Item ID: D206-667-103TRN

Item Name: Crosstube Turning DetailL

DART AEROSPACE LTD		Work Order:	97486
Description: Crosstube Assembly (206L High Fwd)		Part Number:	D206-667-143
Inspection Dwg: D206-667-143 Rev: C		Page 1 of 2

DRAWING NO. D206-667-143	TITLE CROSSTUBE ASS'Y (206L HIGH FWD)	REV. C	DART AEROSPACE LTD ENGINEERING ORDER		D.E.O. NO. D206-667-143-C-1	SHEET NO. SHEET 1 OF 1	SCALE NTS
DRAWN <i>q</i>	CHECKED <i>ASS</i>	MFG. APPR. <i>[Signature]</i>	APPROVED <i>[Signature]</i>		DE APPR. <i>[Signature]</i>		
DATE 11.07.15	DATE 11.07.20	DATE 11.07.21	DATE 11/07/21		DATE 11.07.21

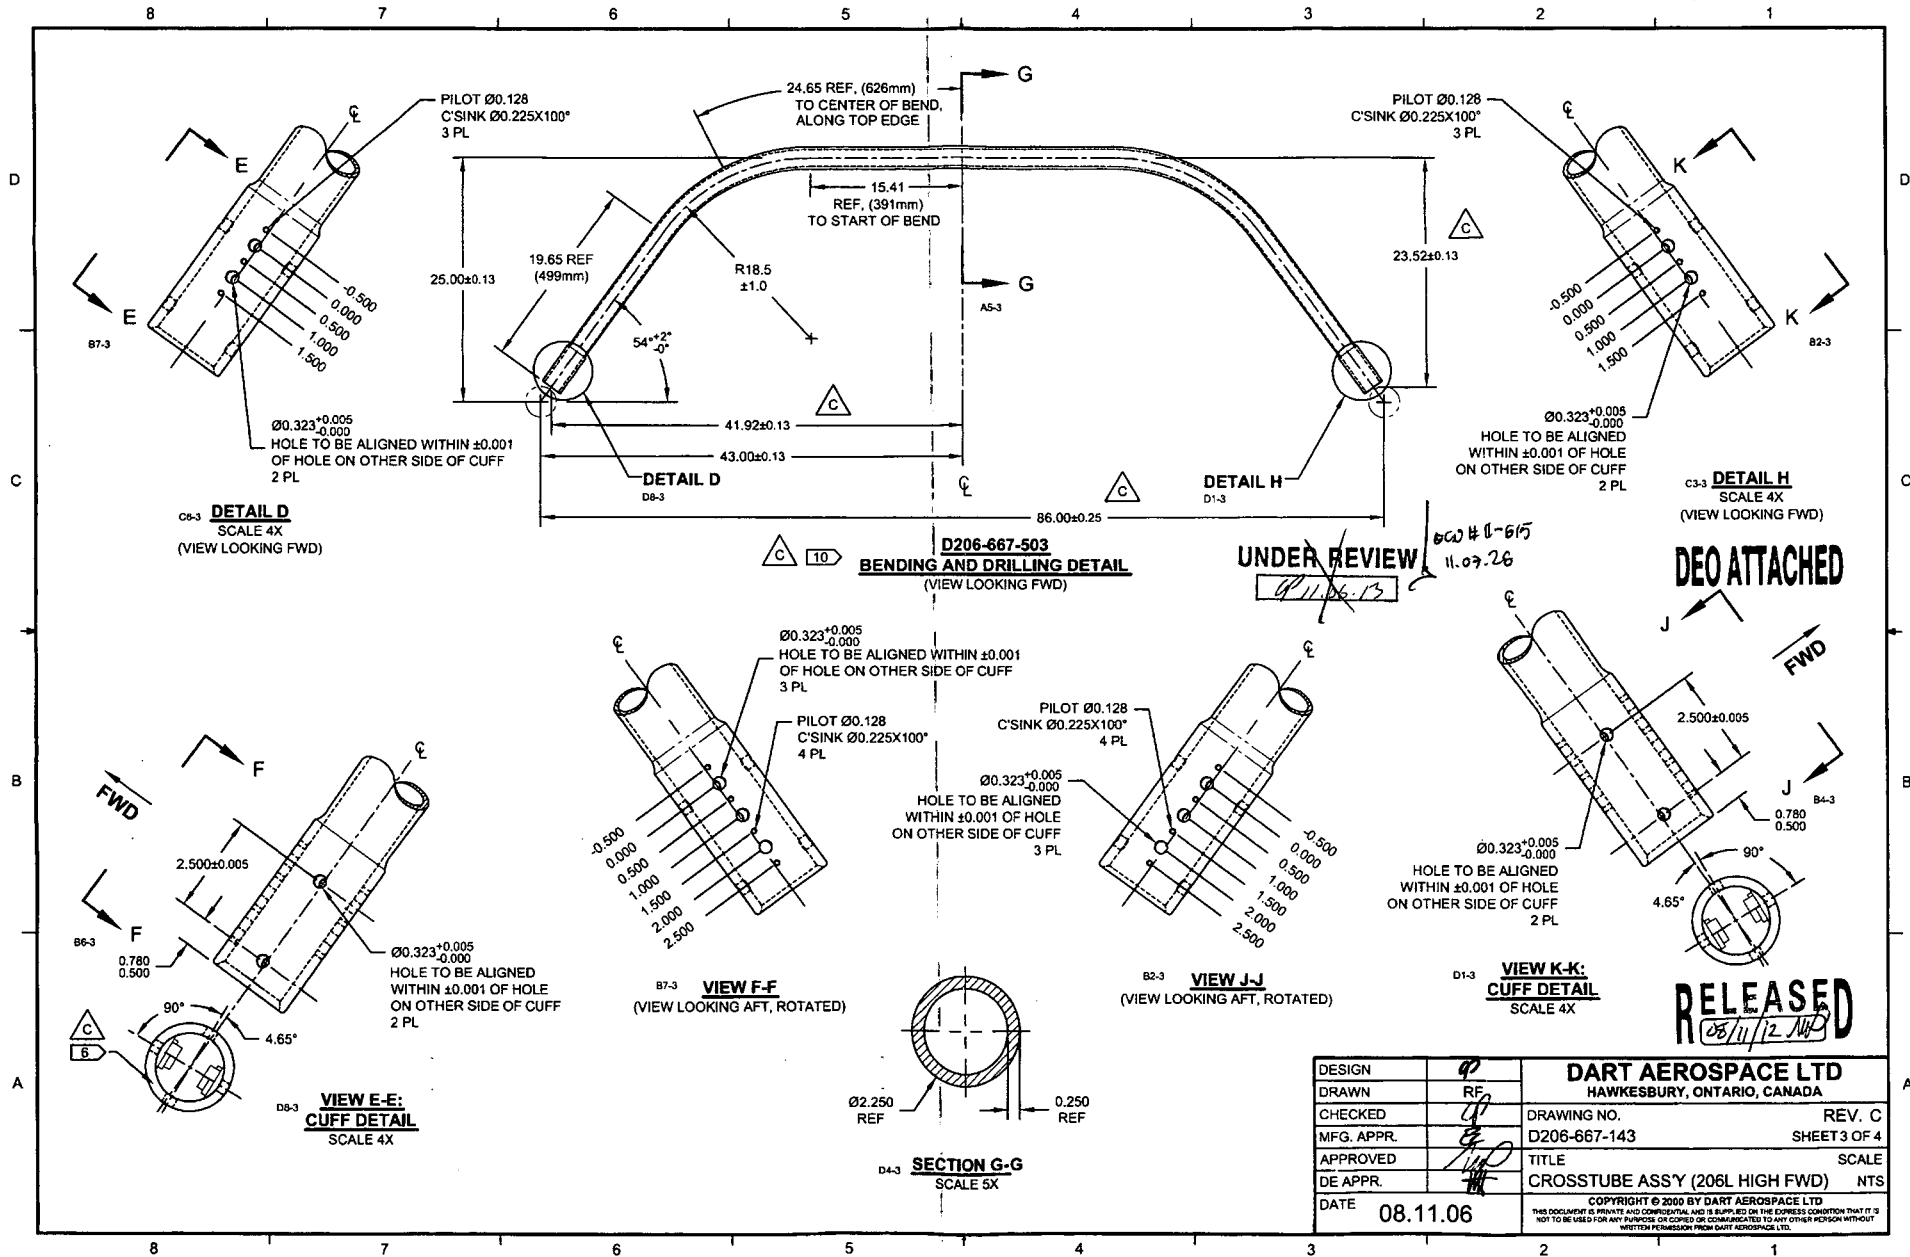
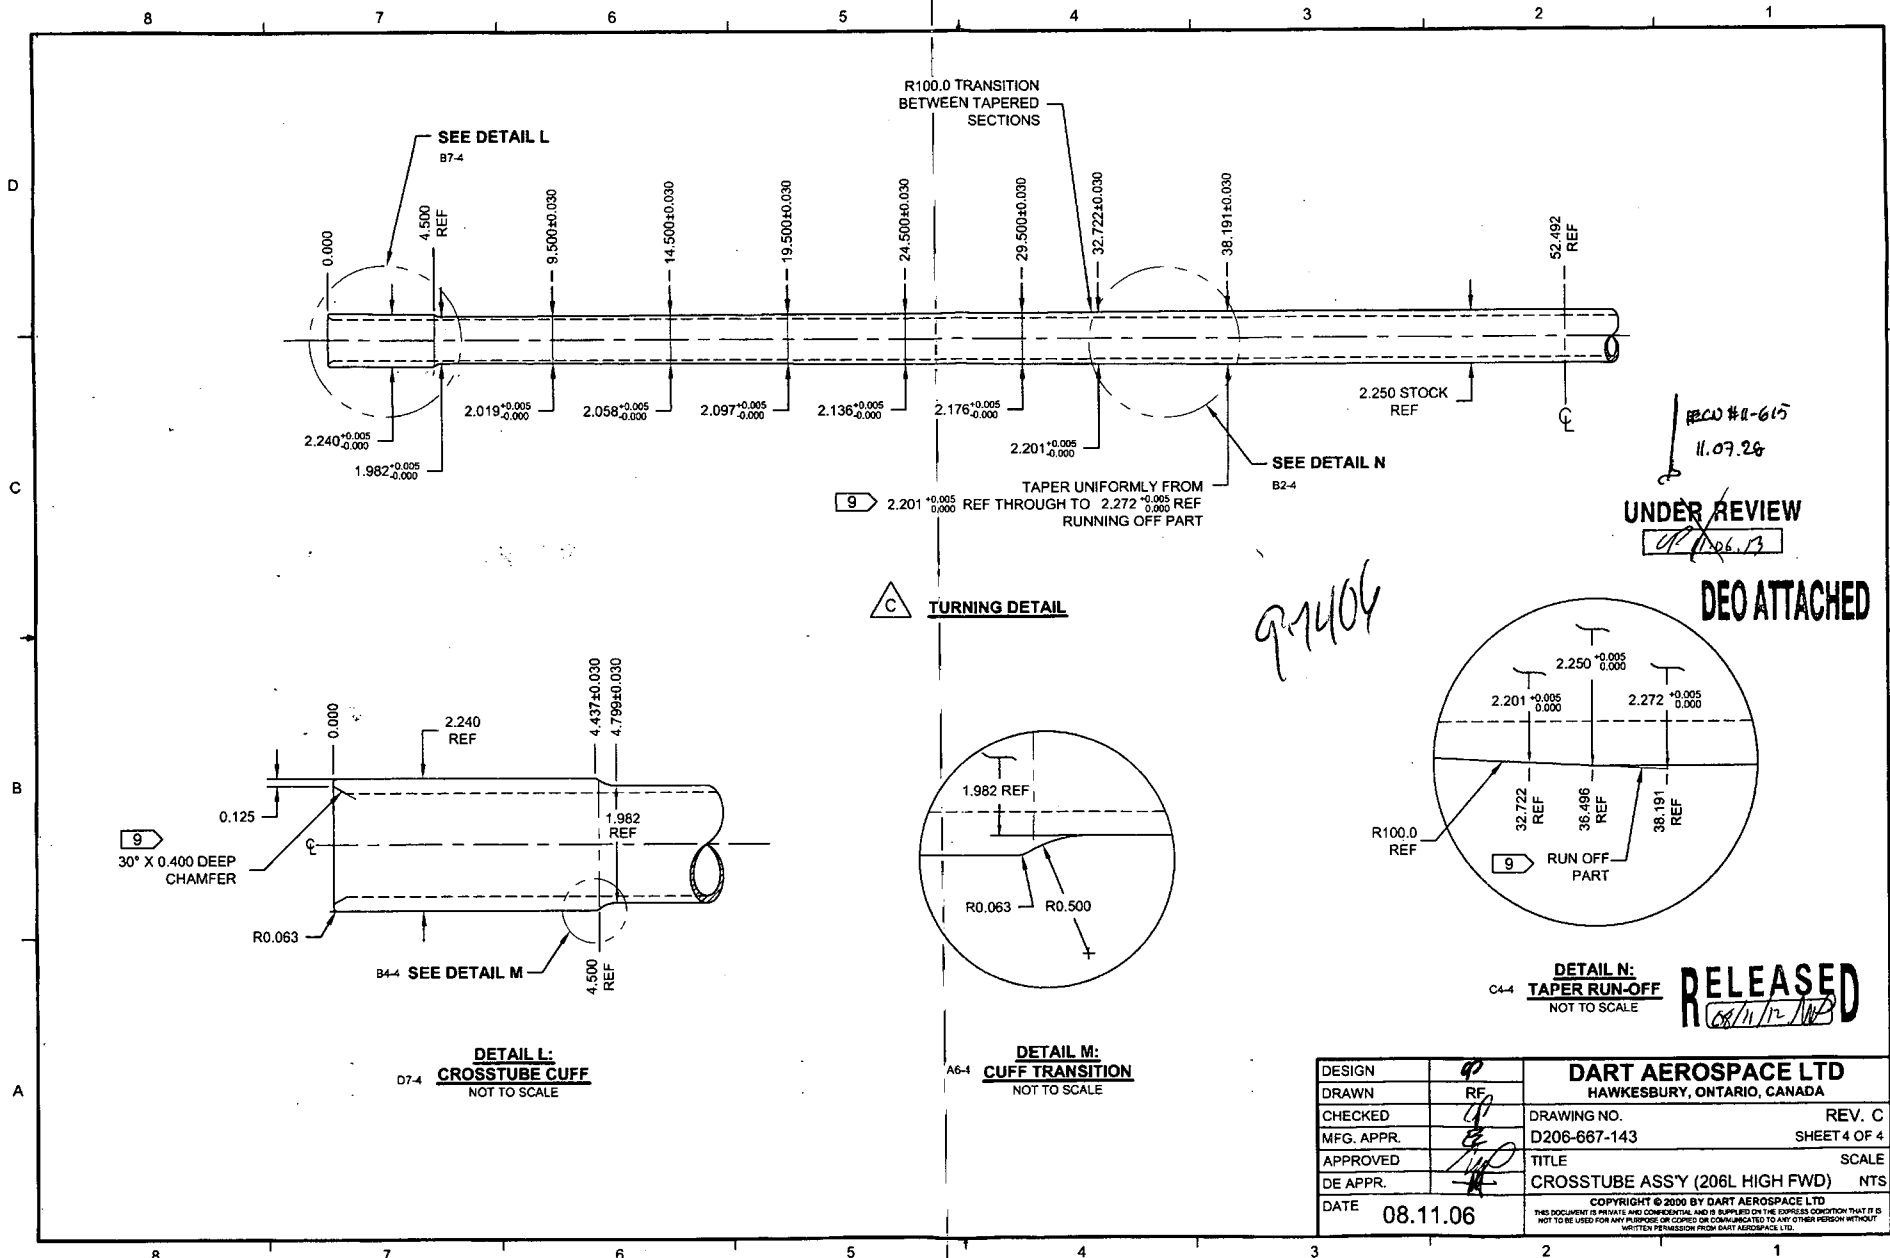
PURPOSE:

REPLACE MAGNOBOND WITH PROSEAL.

NOTE 12 & 15, SHEET 1 IS AMENDED AS FOLLOWS:

IS:

Item	Qty -143	Part Number	Description
9	A/R	PROSEAL 890 B-2	SEALANT, AMS-S-8802 CLASS B-2

12) TO INSTALL D2891-1 SUPPORT: ABRASE MATING SURFACE OF SUPPORT AND CROSSTUBE WITH 180-GRIT SANDPAPER AND REMOVE RESIDUE WITH MEK (OR EQUIVALENT). APPLY A 0.04" TO 0.07" THICK LAYER OF PROSEAL 890 CLASS B-2 (OR AMS-S-8802 CLASS B-2) SEALANT TO MATING SURFACE OF SUPPORT.

15) TORQUE CLAMPS 80 TO 100 IN-LB. ENSURE AT LEAST 1.5 THREADS SHOWING IN SAFETY AND THAT NUT HAS NOT BOTTOMED-OUT AFTER TORQUING. **PRIOR TO PACKAGING, RE-CHECK TORQUE ON CLAMPS AFTER PROSEAL 890 SEALANT HAS CURED FOR 72 HOURS.**

DETAIL P
BONDING STRAP INSTALLATION 2 PL

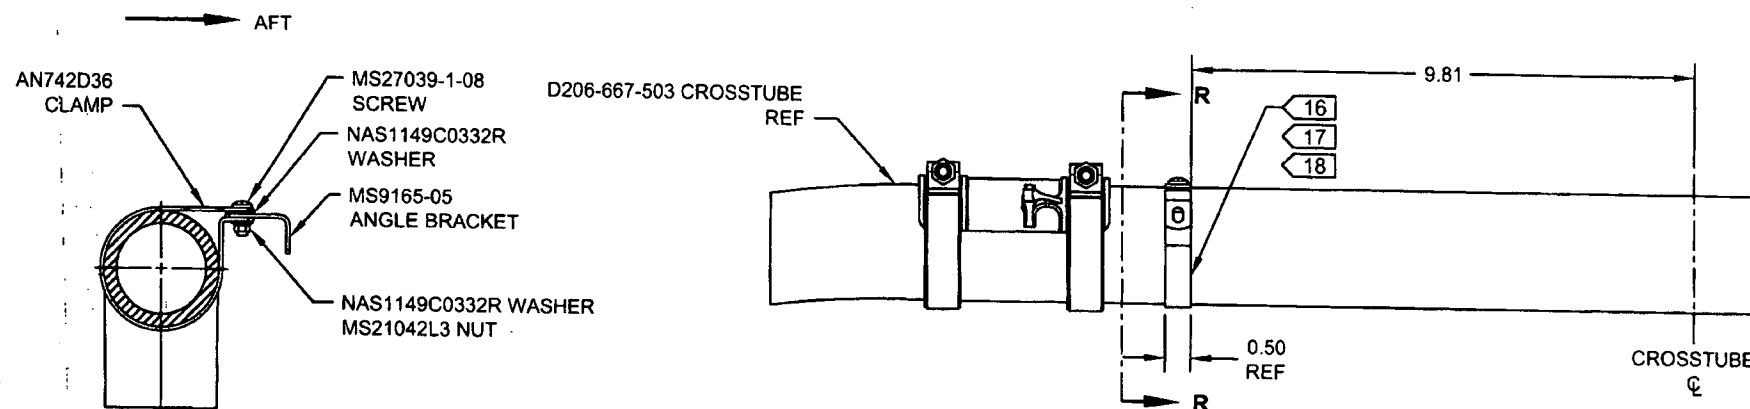
PURPOSE:

ADD ELECTRICAL GROUNDING STRAP

ITEM	QTY -143	PART NUMBER	DESCRIPTION
1	X	D206-667-143	CROSSTUBE ASSEMBLY (206L HIGH FWD)
10	2	AN742D36	CLAMP
11	2	MS9165-05	ANGLE BRACKET
12	2	MS21042L3	NUT (OR MS21042-3)
13	2	MS27039-1-08	SCREW
14	4	NAS1149C0332R	WASHER (OR AN960C10L)

- 16) MASK AREA UNDER CLAMP PRIOR TO PAINTING
- 17) SEAL EDGES WHERE AN742D36 CLAMP MEETS WITH THE CROSSTUBE USING SIKAFLEX-241/-291 OR MIL-S-8802 CLASS B2 OR PROSEAL 890 SEALANT
- 18) PERFORM RESISTANCE CHECK TO ENSURE MAX RESISTANCE IS 10 MILLIOHMS
